From: Sean.Rix
Sent: 09 May 2025 14:16
To: Marie.Riggs; Planning
Subject: DC/25/0548 5 Coach House Mews, Horsham Road, Cowfold

Dear Marie,

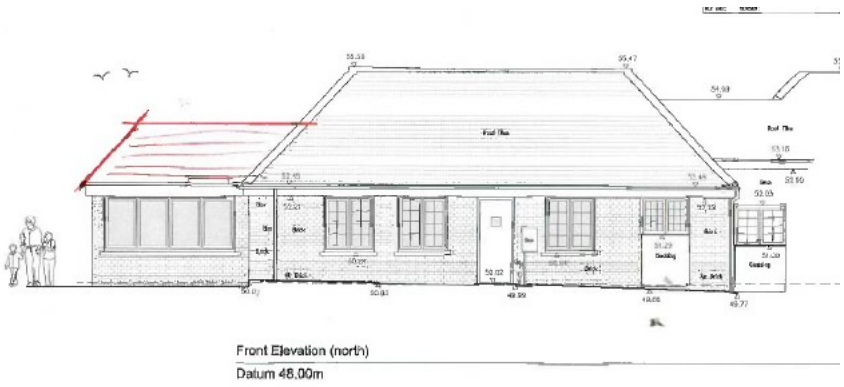
In order to preserve the character of the conservation area it is important any further structures reflect a traditional form. In this case I am satisfied the principle is acceptable but the extension should have a pitched roof. To keep the overall height down I have suggested a double pitched roof. Please see the images below. Feel free to send to the applicant.
